Re: Petition No. Petition 1344 - Greenhill to Bokum Upgrade Project - 1342 Line

Response to CSC-01 Interrogatories dated 06/18/2018  
CSC-001, 003, 004, 005, 006, 008

**CL&P dba Eversource Energy**  
**Petition No. Petition 1344**

Sheet 15 of 19

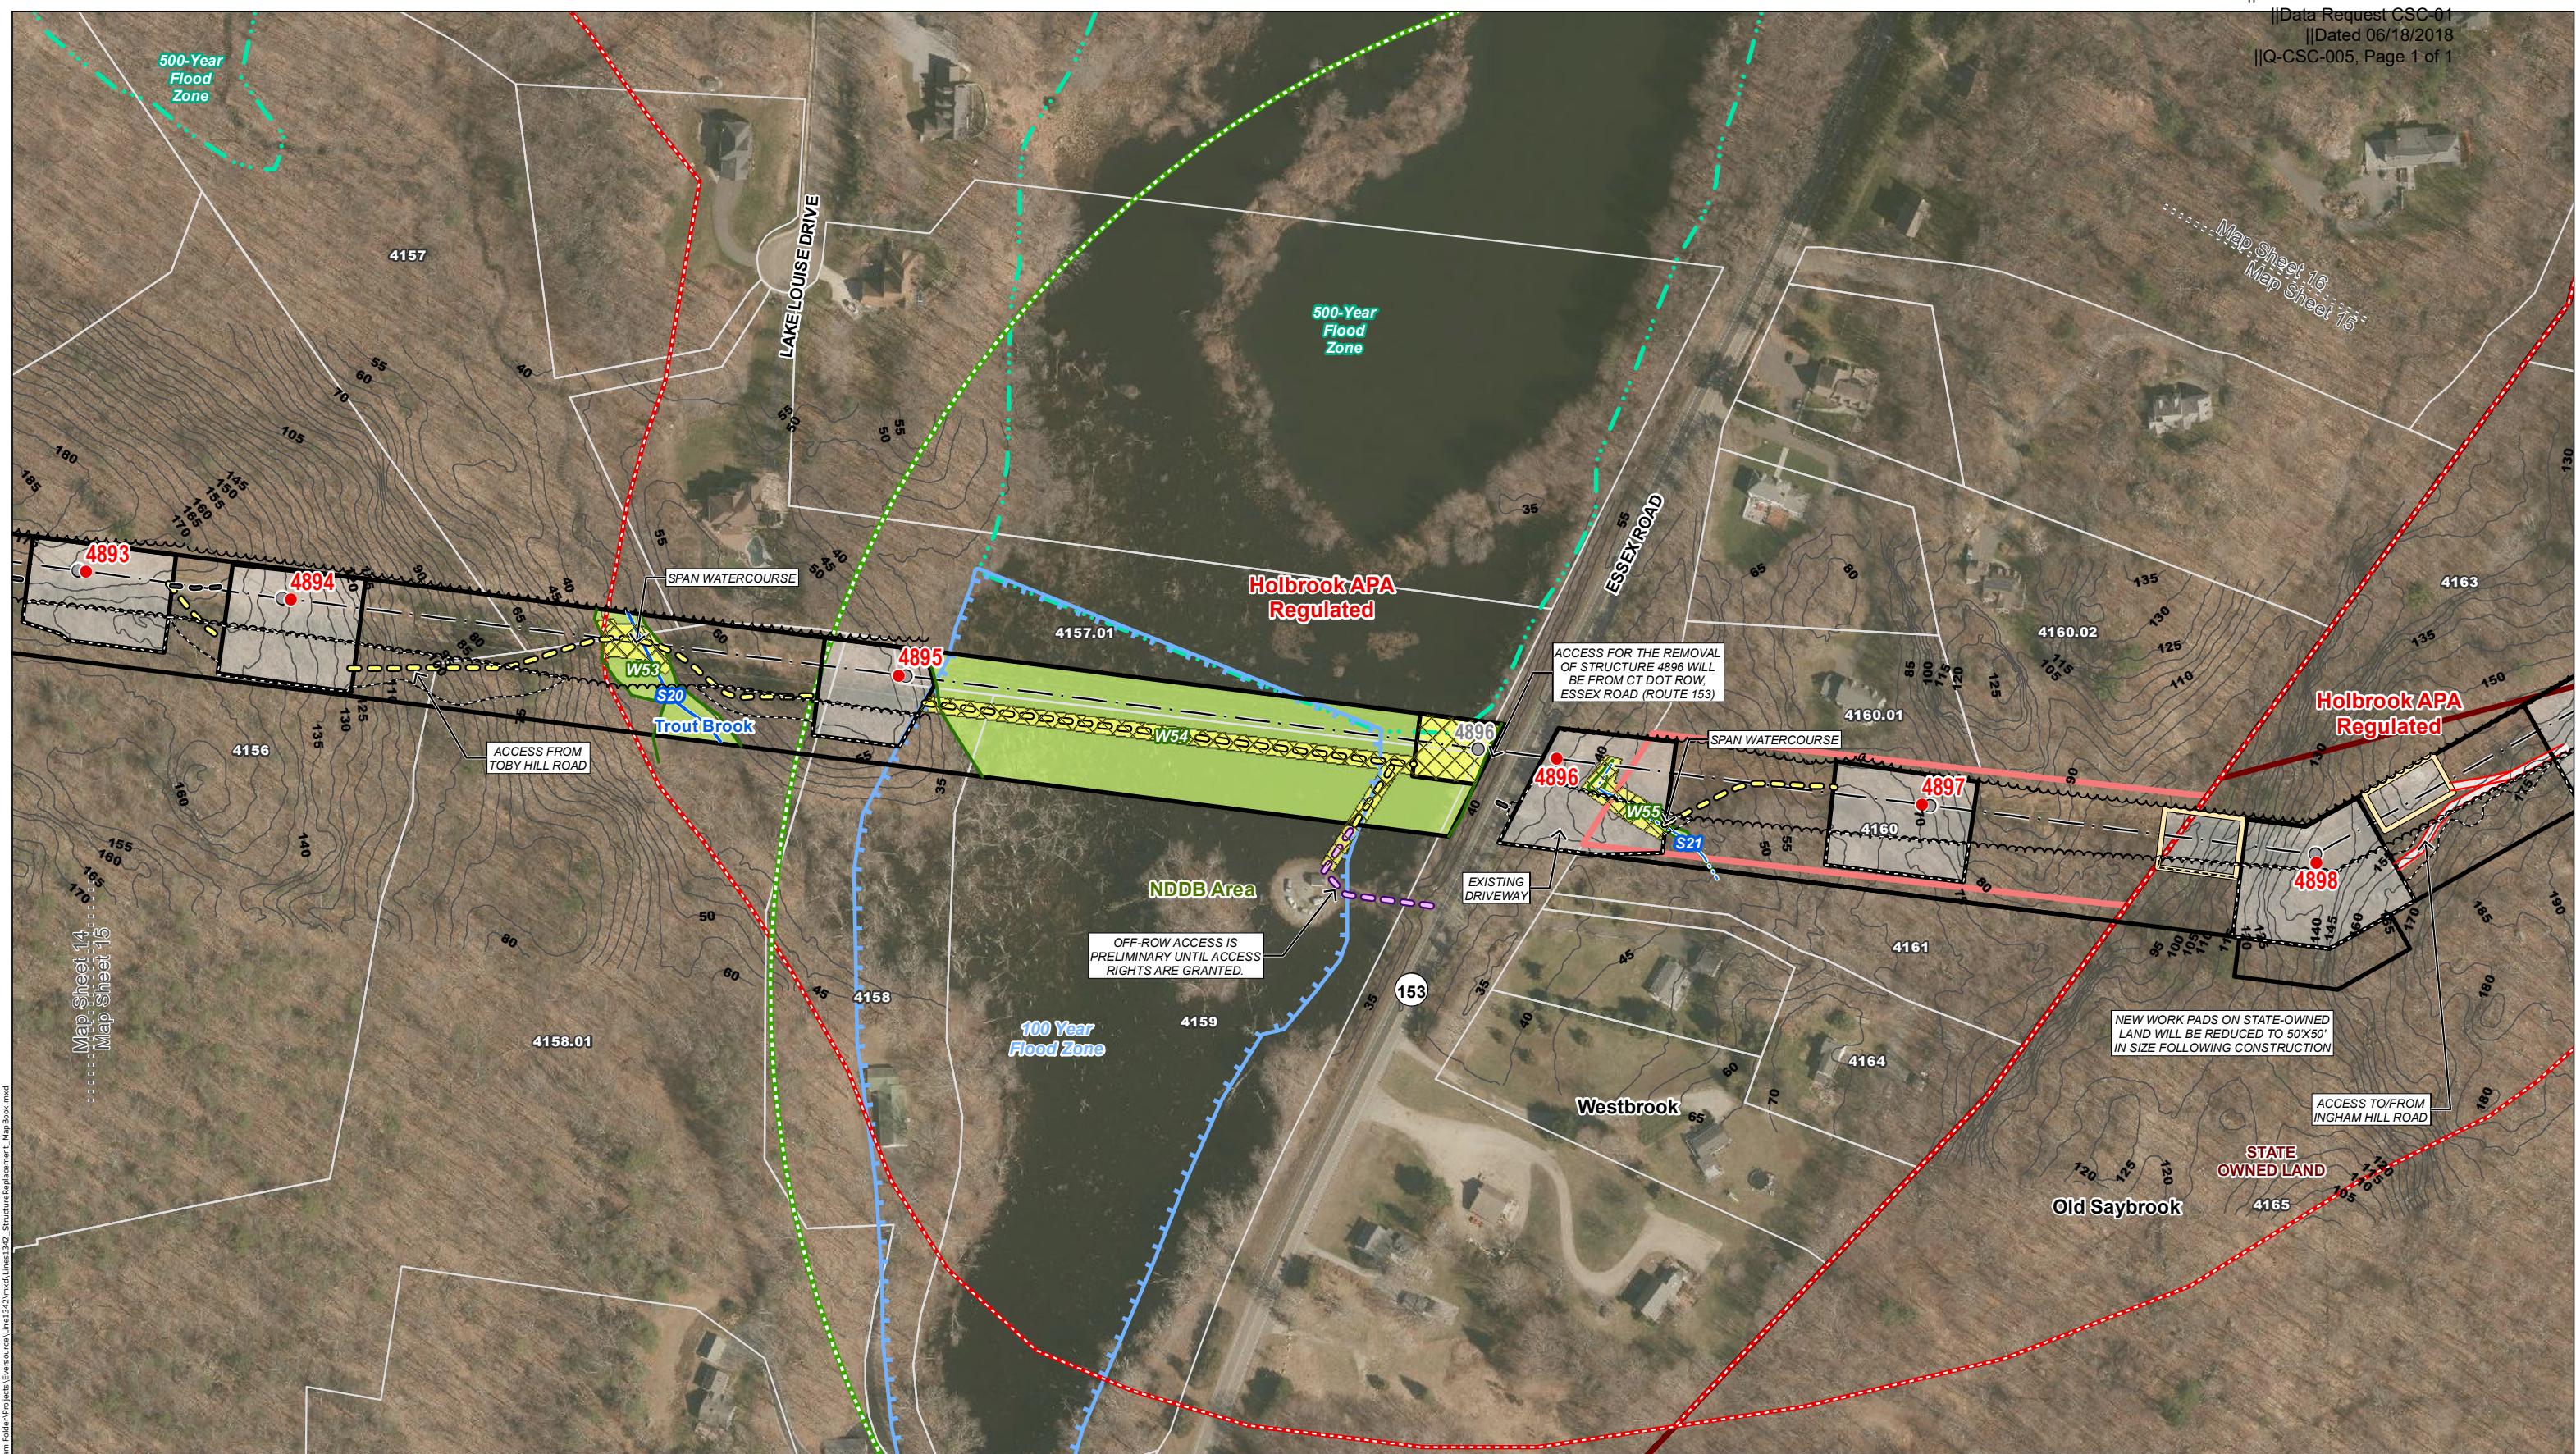
Referring to Map 15, the text box above Structure 4896 mentions access to Structure 4898-  
is 4898 a misprint?

Yes, it is a misprint. The text in the box above Structure 4896 should state STRUCTURE  
4896. The revised Map Sheet 15 is attached.

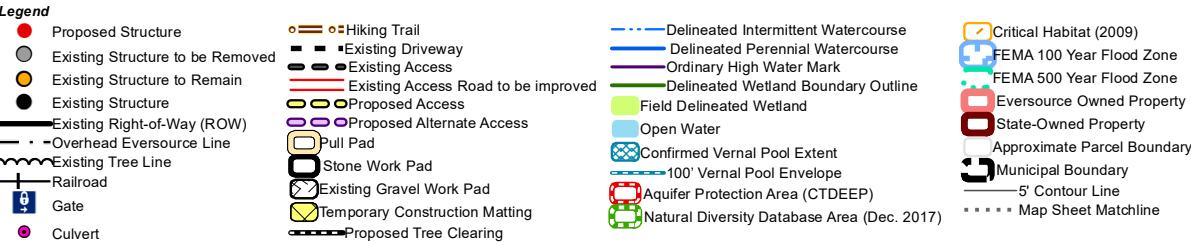
Is it possible to access Structure 4828 from the east, and within the existing right-of-way, to avoid disturbance to VP4?

Yes, Eversource can use temporary construction matting within the existing right-of-way from Structure 4829 to Structure 4928; thereby, eliminating the need for matting over an existing access road through VP4. This new access is depicted on revised Map Sheet 4, attached.
